PLANNING COMMISSION

Meeting Date: April 23rd, 2026

AGENDA ITEM: 6.A

REQUEST: Site Plan Review; Preliminary Major Condominium (Open Space Development Option)

SOIL DISPERSAL SYSTEM LAYOUT
SCALE: 1" = 40'

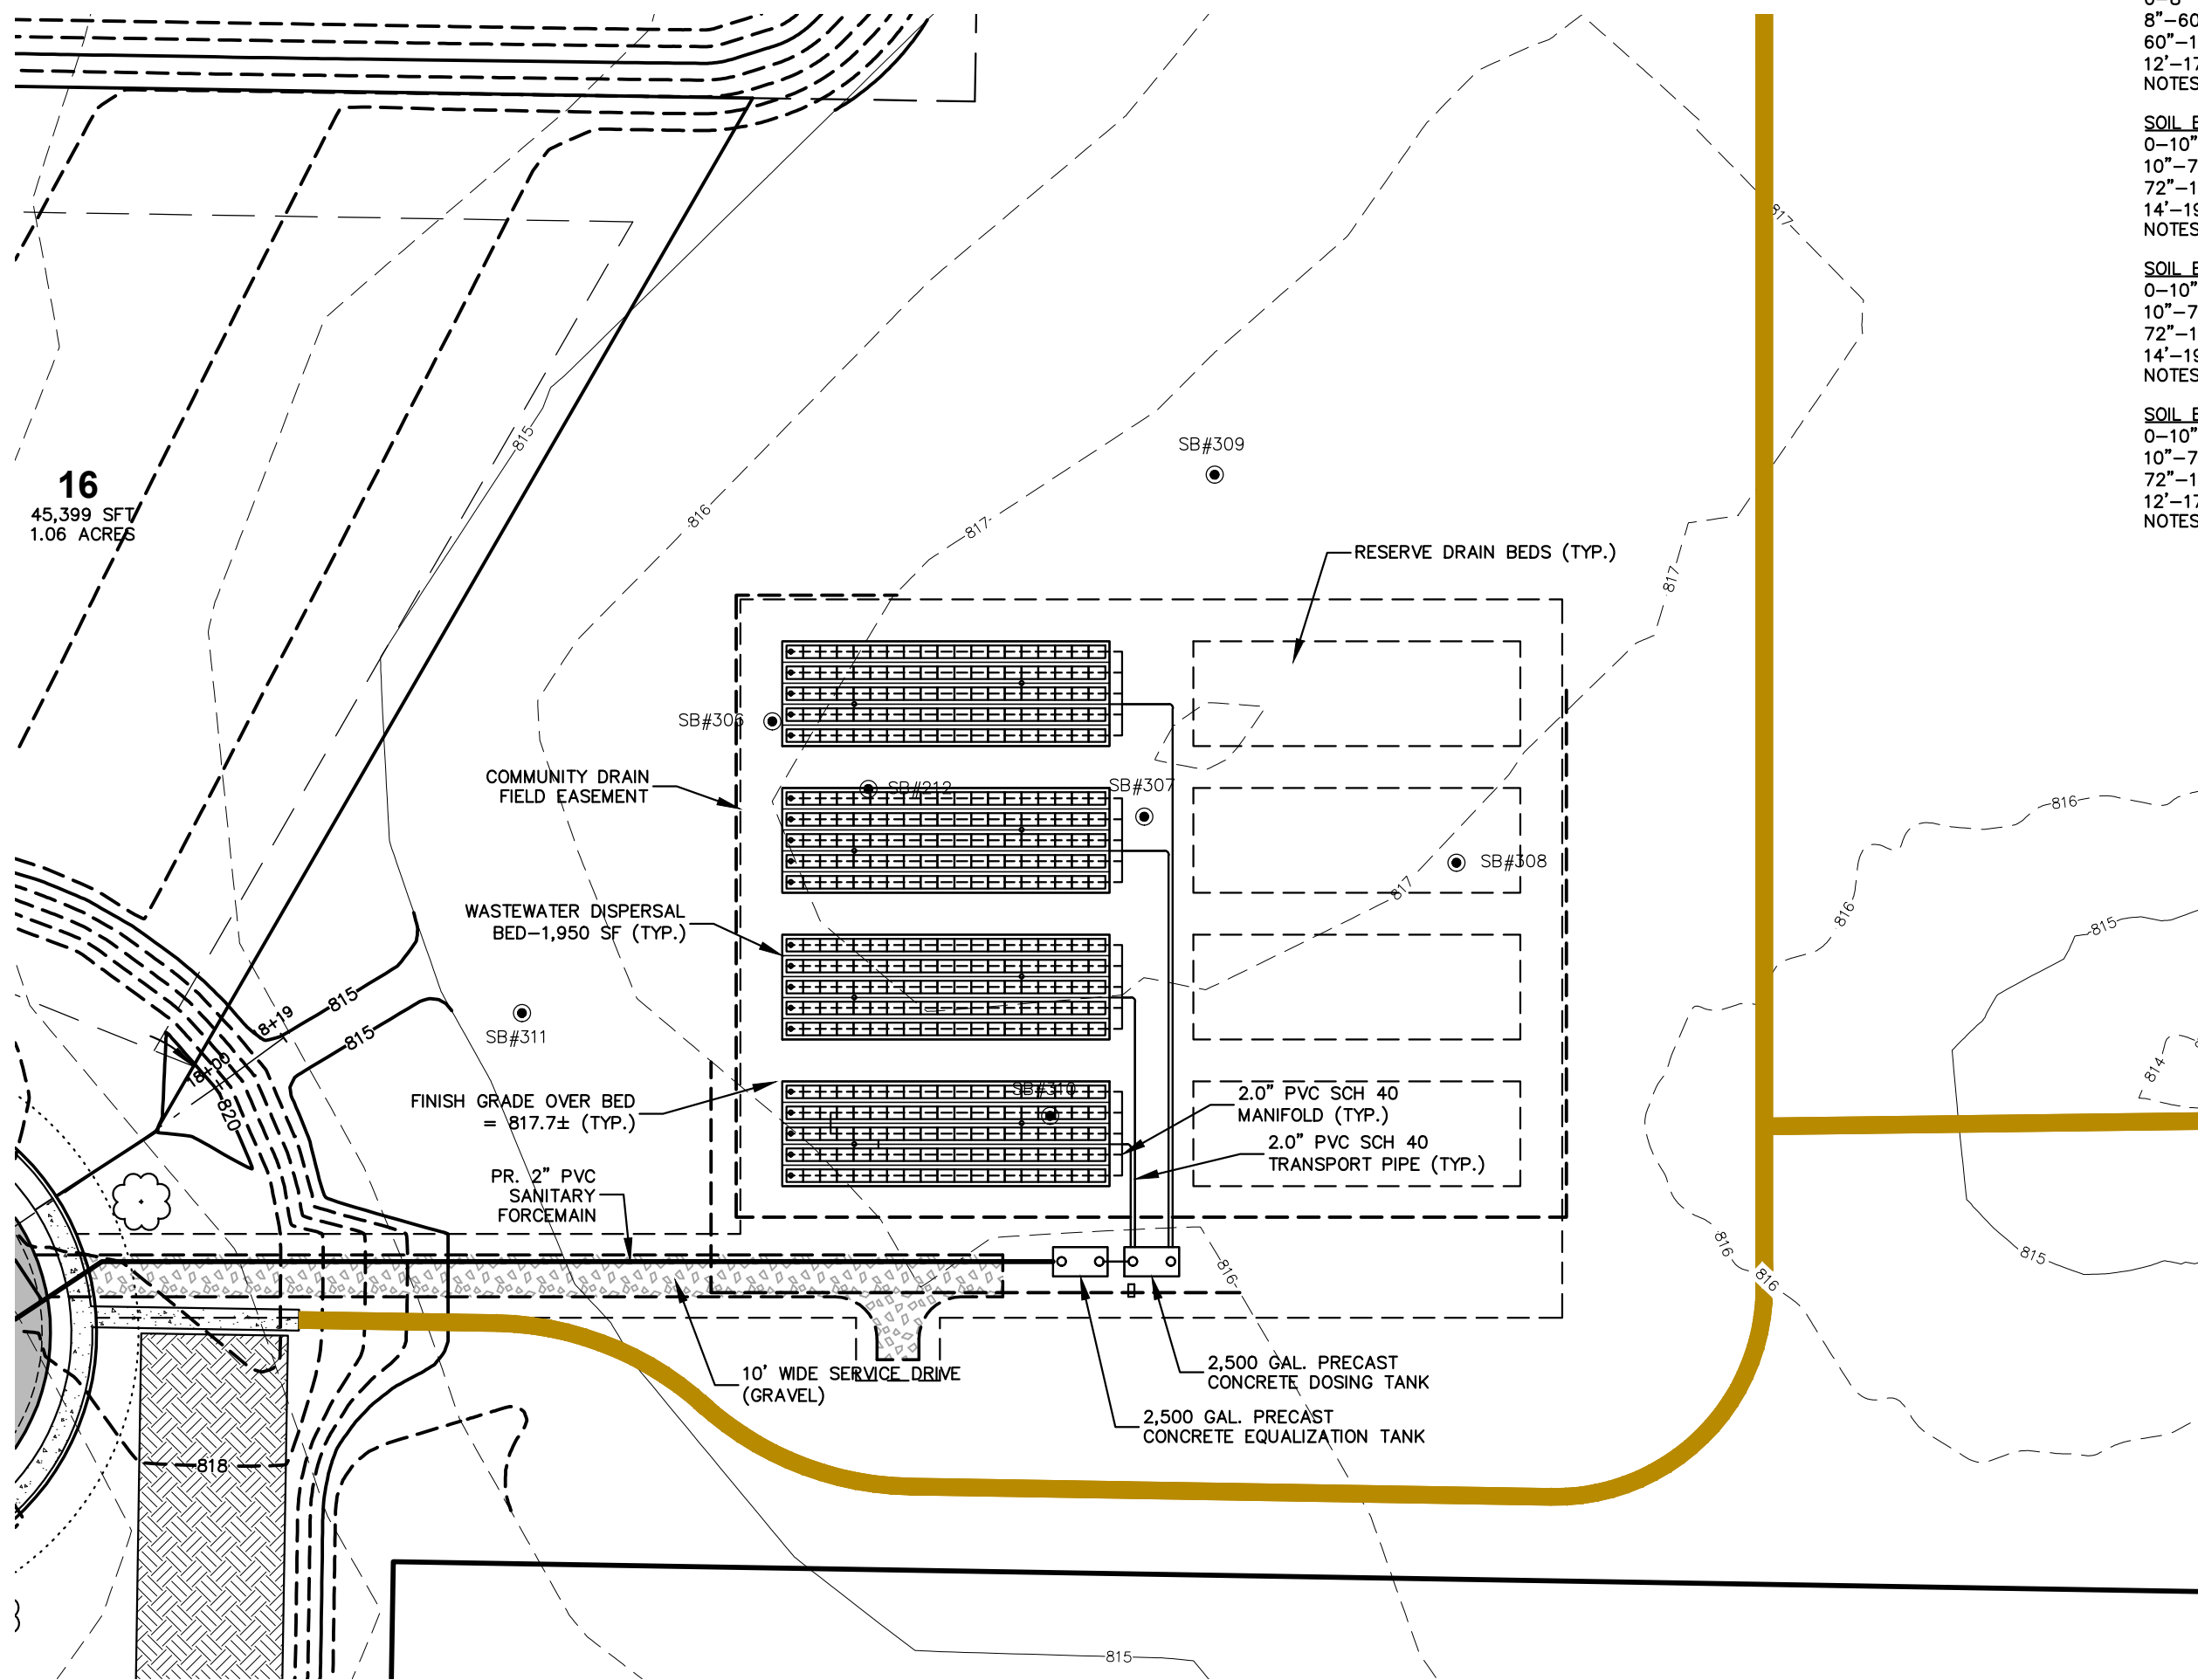
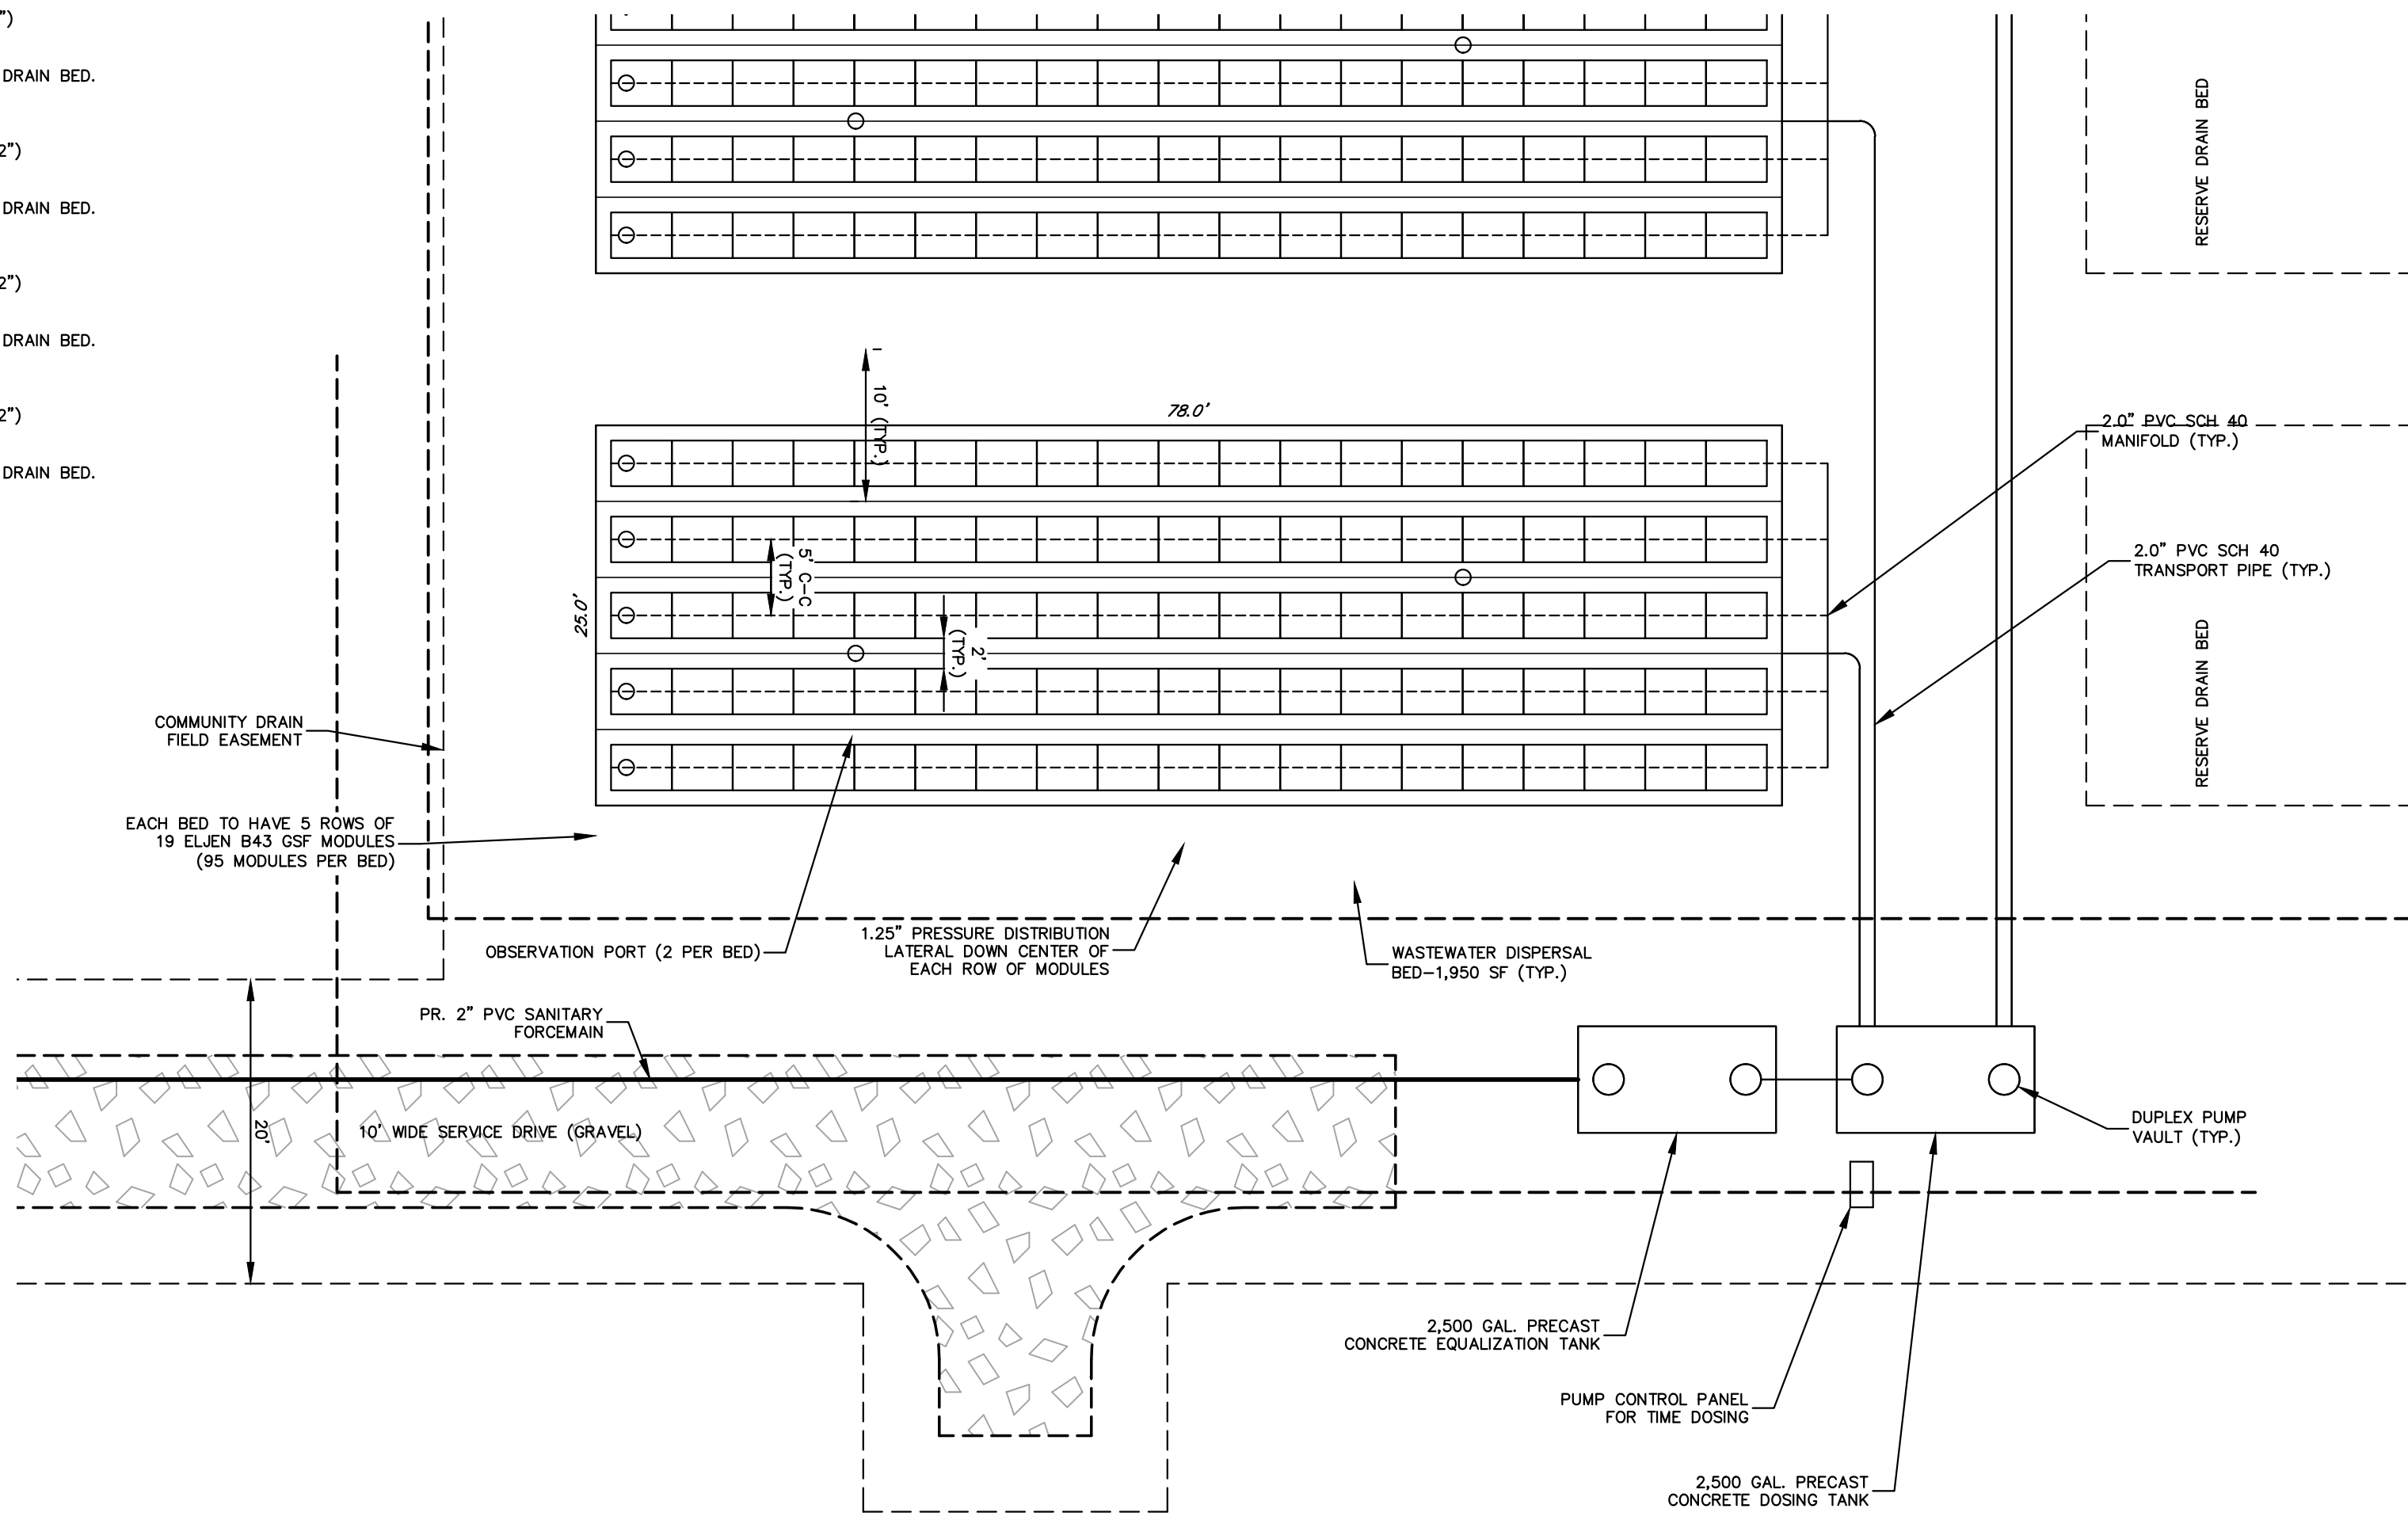
Does not meet standard. The site plan indicates that there will be two large detention basins to the west of the proposed homes, and one smaller detention basin to the east, which is an existing drainage course. There will be four private drainage easements, three of which will be between lots on the west side of the street and one which will be between lots on the east side of the street. The applicant has also specified that all existing field tile drains within the 100-foot isolation buffer for the drain fields will be relocated to be outside of the isolation area.

Undetermined, condition recommended. The applicant is proposing a private community septic system to serve the 30 residential lots, which will each have their own individual well. Although the proposed plans have no bearing on the BGUA's ability to provide public services, the Township Engineer's review dated 04/15/2026 indicates several deficiencies which must be addressed through updated plan sets. Final plans must be reviewed and approved by the Township Engineer and the Kent County Health Department.
